<b>Notice of Allowability</b>	<b>Application No.</b>	<b>Applicant(s)</b>	
	10/676,726	THORNTON ET AL.	
	<b>Examiner</b>	<b>Art Unit</b>	
	Burton S. Mullins	2834

### EXAMINER'S AMENDMENT

FIG. 4

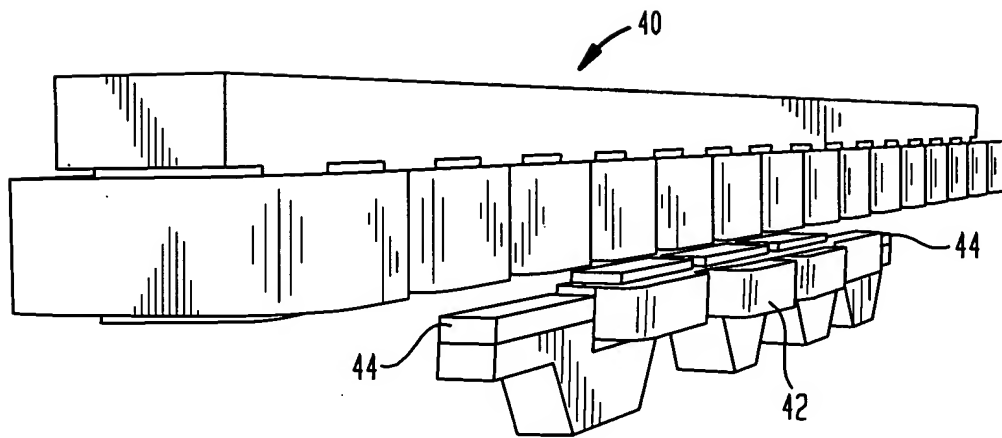
Enter Replacement Sheets for Figs.4, 7 and 8.
